# Access Compliance Report

## Public Rights-of-Way

### (Curb Ramps)

Intersection ID: 12797	Main Street: N_MYERS_ST	Cross Street: E_6TH_ST	Location: E
ADA ID: 90917FF75F49	Ramp Type: BlendTrans1	Initial Pass/Fail: Fail	Overall Compliance: No
Severity Score: 8.75			
Codes/Mitigation Info/Possible Solution		Field Measurements/Component Compliance

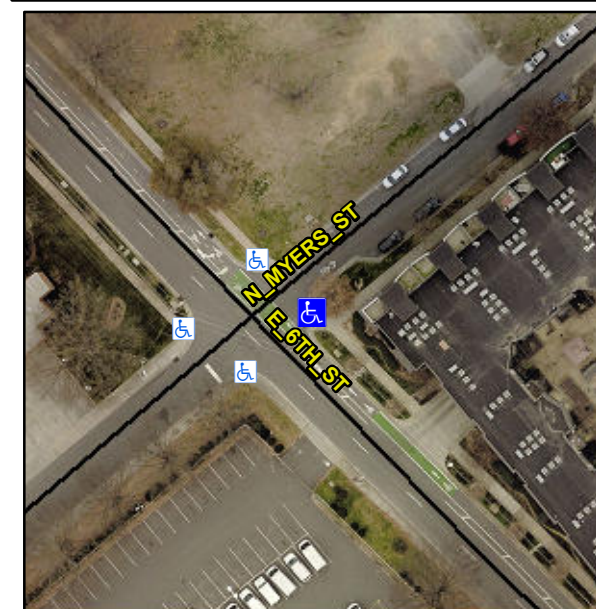
**CURB GAP 2.0**

**Not Found, R304.5.1**

Compliance	Description	Data	Compliance	Description	Data
N/A	Ramp Length (in)	102.0	Yes	BlendTrans Slope (%)	3.6
No	Ramp Width (in)	47.5	Yes	BlendTrans XSlope (%)	0.8
N/A	Flare Type LT	N/A	N/A	Flare Type RT	N/A
N/A	Flare Slope LT (%)	N/A	N/A	Flare Slope RT (%)	N/A
N/A	Flare Traversable LT?	N/A	N/A	Flare Traversable RT?	N/A
N/A	Landing Length (in)	N/A	N/A	DWS Provided?	N/A
N/A	Landing Width (in)	N/A	N/A	DWS Contrast?	N/A
N/A	Landing Slope (%)	N/A	N/A	DWS Length (in)	N/A
N/A	Landing X Slope (%)	N/A	N/A	DWS Full Width?	N/A
N/A	Landing Curb? (Y/N)	N/A	N/A	DWS Offset (in)	N/A
N/A	Shared Landing?	N/A			
N/A	Gutter Ponding?	N/A	N/A	Gutter Slope (%)	N/A
N/A	Gutter Lip Ht (in)	N/A	N/A	Gutter X Slope (%)	N/A
N/A	Painted X Walk1?	No	N/A	Painted X Walk2?	No
	X Walk 1 Direction	To NW		X Walk 2 Direction	To SW
	X Walk 1 Width (in)	N/A		X Walk 2 Width (in)	N/A
	X Walk 1 Slope (%)	0.6		X Walk 2 Slope (%)	1.9
	X Walk 1 X Slope (%)	4.0		X Walk 2 X Slope (%)	0.8

N/A	Ramp inside XWalk1?	N/A	N/A	Ramp inside XWalk2?	N/A
	Road Slope (%)	1.7		Clear Space?	N/A
	Road X Slope (%)	2.8	N/A	Clear Space to XWalk (in)	N/A
N/A	Any Obstructions?	N/A	N/A	Storm Grate/Utility Hazard?	N/A
	Obstruction Type			Storm Grate/Utility Type	
		N/A			N/A
			Yes	Surface Condition? (G/P)	Good
			No	Curb Slope (%)	21.3

**Remove & Replace Curb Ramp With Two New Directional Ramps or Equivalent.**
